RE: Objection to DA2024/0284 – 34 Pavilion St Queenscliff NSW 2096

We write to you to object to the proposed development at 34 Pavilion St Queenscliff, Application reference number DA2024/0284 submitted 22/03/2024.

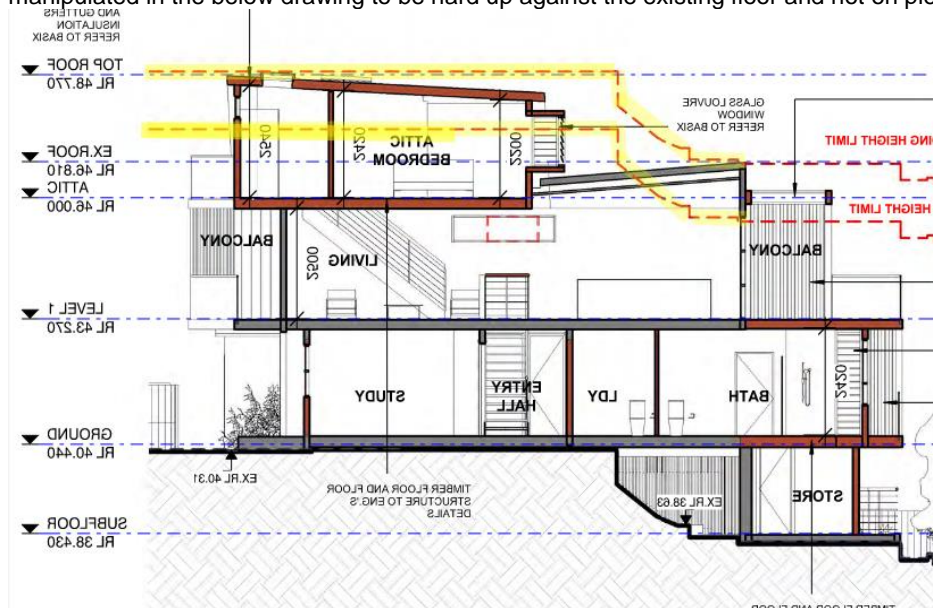
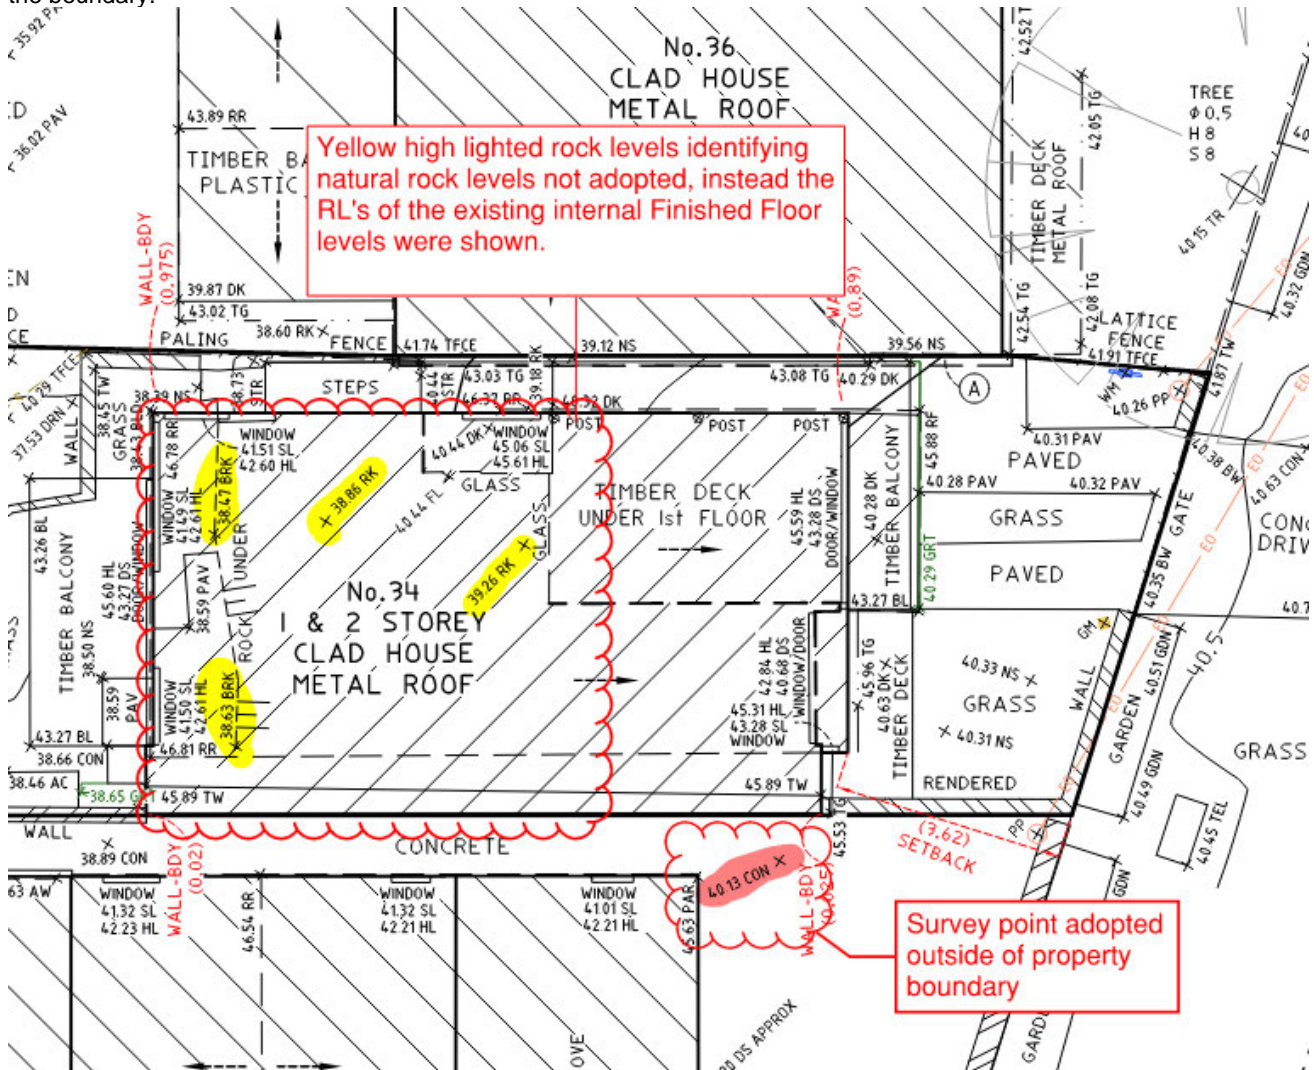
You will note these maximum height lines looks vastly different on the applicant's recent submission DA2024/0284. Extract of section below that shows these building control lines considerably higher, (maximum 8.5m building height line and maximum 7.2m wall height line shown marked in yellow).

These control lines have been shown up to approx. 1.7m higher than the approved DA2022/1598. For ease the below image is mirrored to show the difference between the two section height lines. You will also note that the natural ground level has been manipulated in the below drawing to be hard up against the existing floor and not on piers which is factually incorrect.

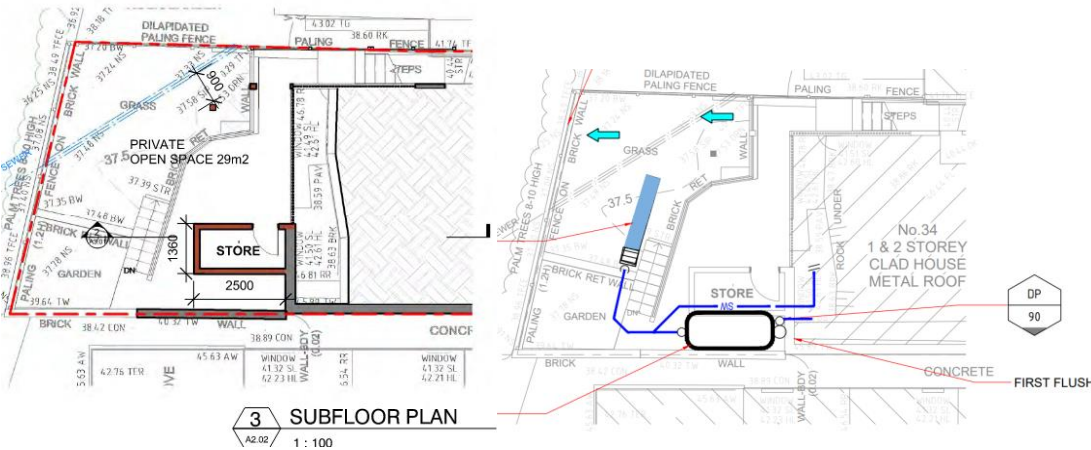
Misleadingly, the applicant has now ignored the survey points as part of their new application. See survey plan on page over identifying the survey points with mark ups in yellow identifying the survey points that were not extrapolated. Instead the applicant has adopted internal finished floor level RL's to attempt to demonstrate higher allowable height lines, and RL's outside the boundary.

In consideration to this omission, and once the survey points have been correctly extrapolated to demonstrate the 8.5m height line, the proposed development grossly impedes on the maximum allowable building and wall height lines.

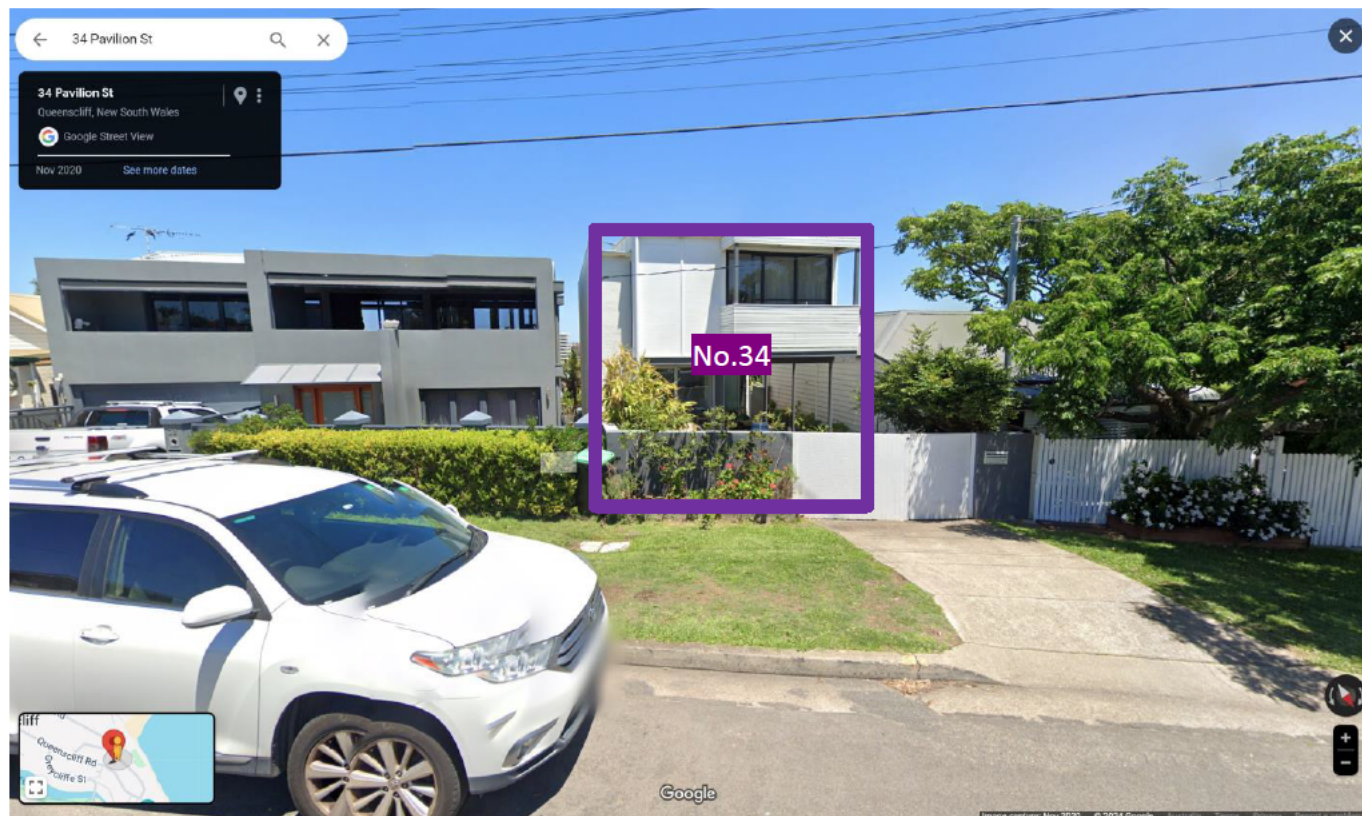
The proposed northern elevation has not identified the existing roof height at the northern elevation street frontage. Instead the RL of the roof at the rear has only been shown.

Referring to the site survey, the existing roof height along the north elevation is positioned at a height of RL45.94. I have marked up this RL line in yellow below. It is apparent the newly proposed walls and roof of the proposed development when viewed from the street are an additional full storey over the existing roof.

It is evident the proposed walls exceed the 7.2m height limit at the street frontage, instead extending all the way to the 8.5m building height limit, despite the applicant's statement of environmental effects ignoring these breaches.

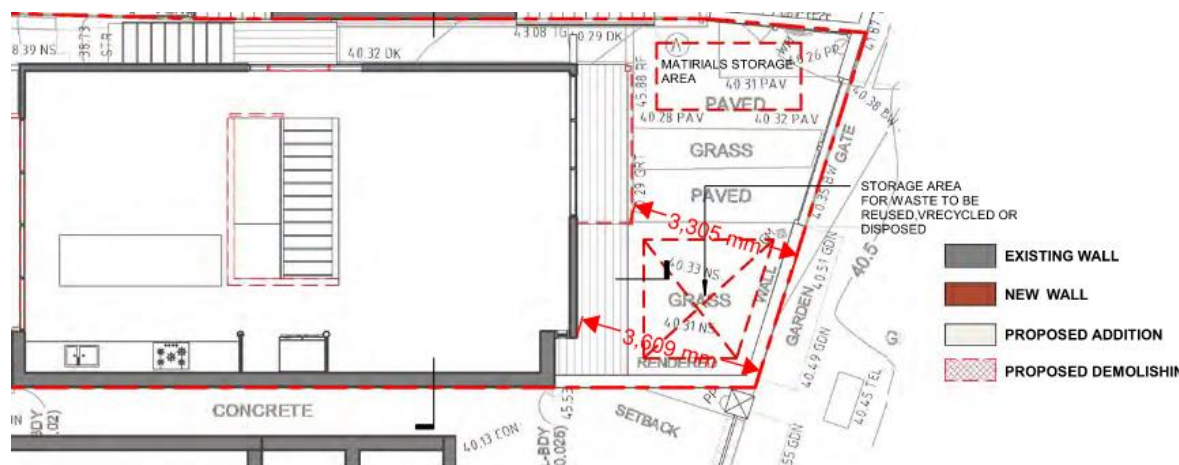
The existing second-storey balcony of the building is currently setback approx. 3.3m, and solid built form set back to approx. 3.6m. The proposed design for the second-storey and third-storey reduces this already minimal street setback of the proposed solid form further to approx. 2.5m. See below scaled mark ups for your reference.

2 EXISTING LEVEL 1 PLAN & PROPOSED DEMOLISHING
A2.01 1:100

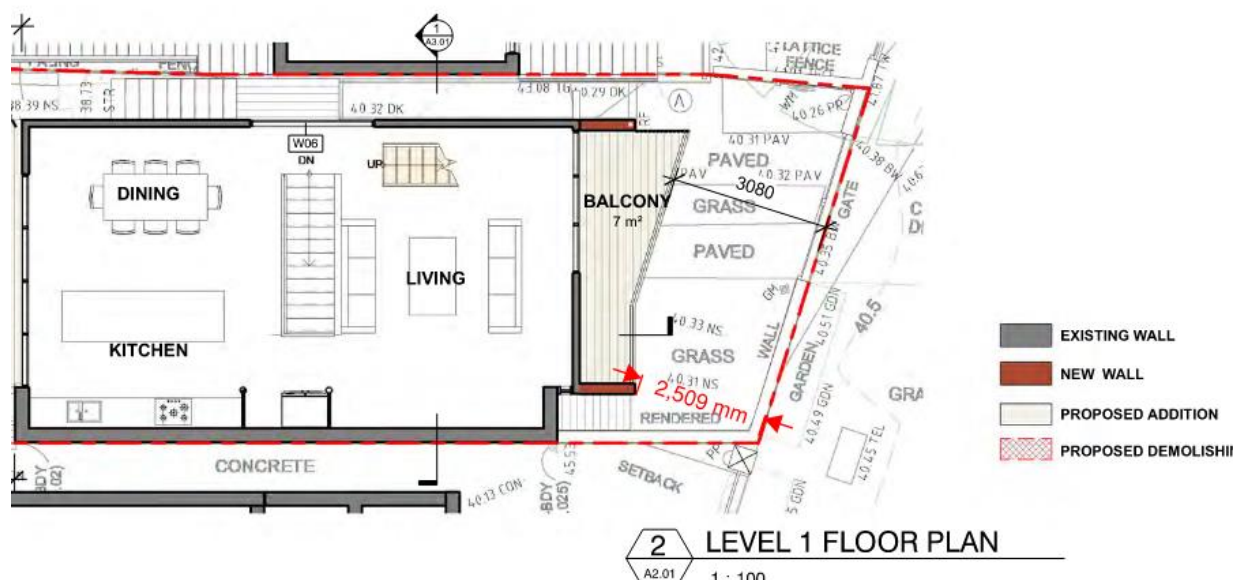
Refer to front setback mark ups below and on the following page.

2 LEVEL 1 FLOOR PLAN
A2.01 1:100

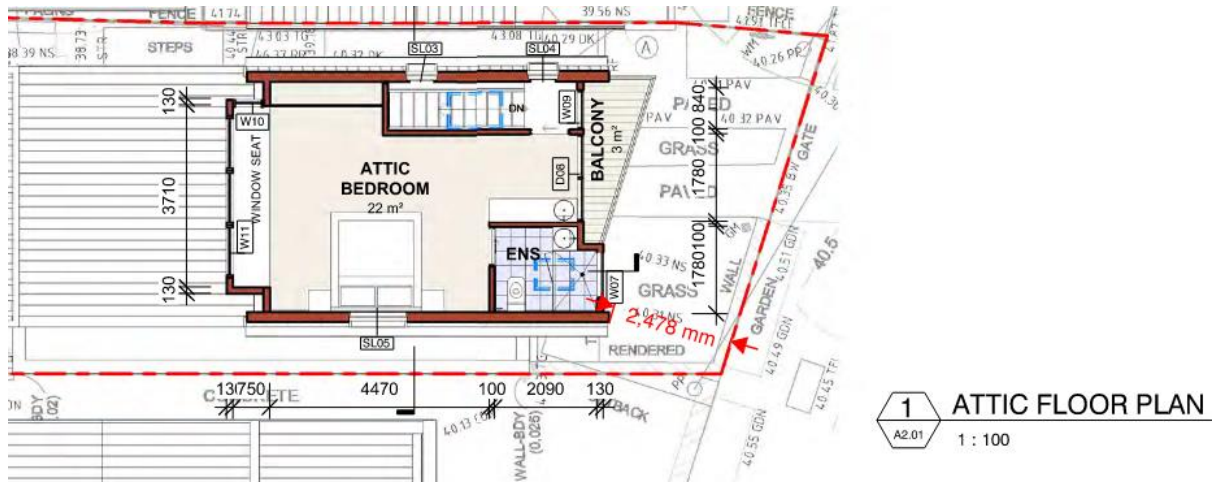
Mark up above showing setback to proposed third-storey as approx. 2.5m from front boundary.

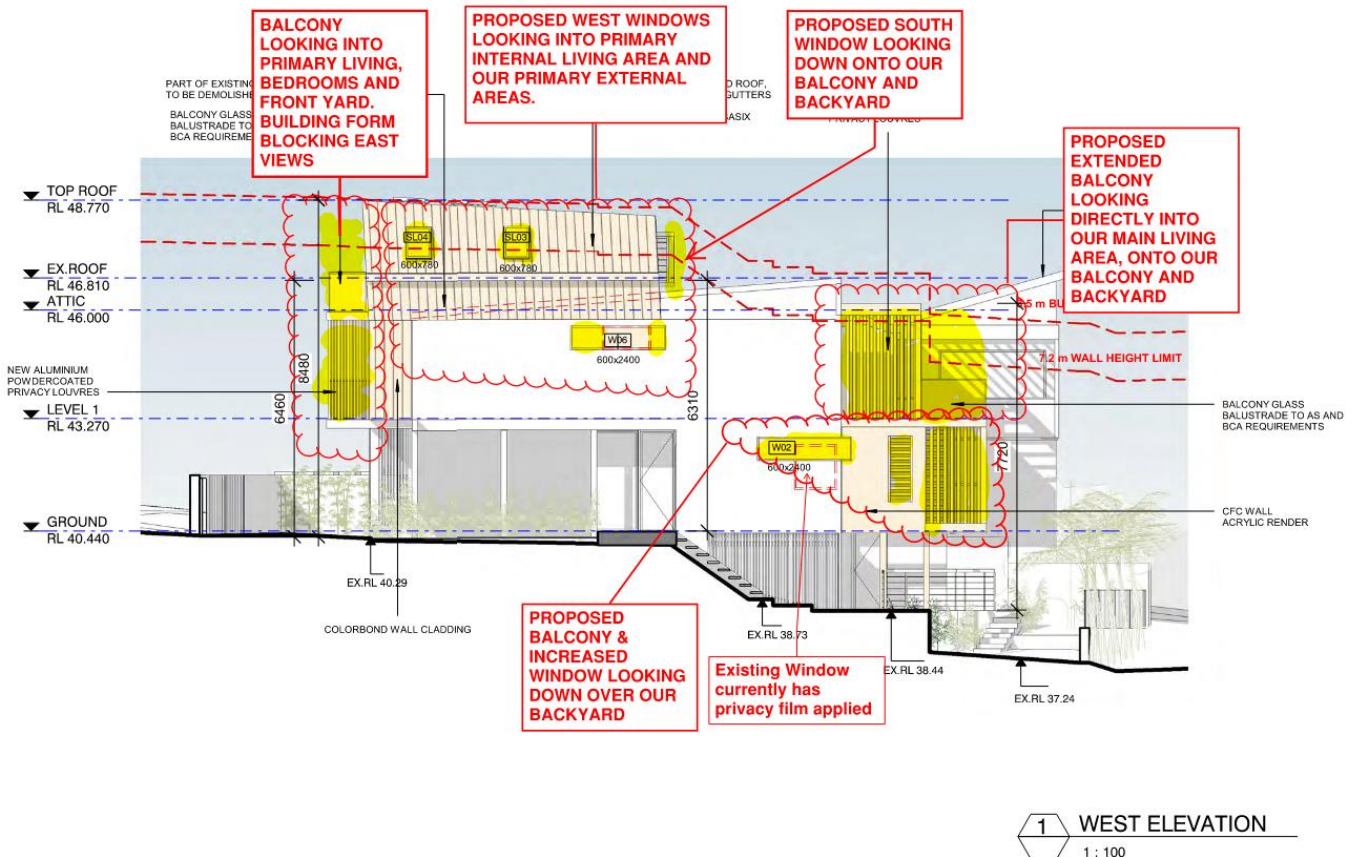
The applicant's plans and shade diagrams appear to have attempted to overlay our DA approved plans, however it is apparent our eastern windows have been omitted from their drawings. It is concerning other building elements may have also been inaccurately shown. Please see mark up below showing approx. location of our DA approved windows / glazing locations on the Eastern side.
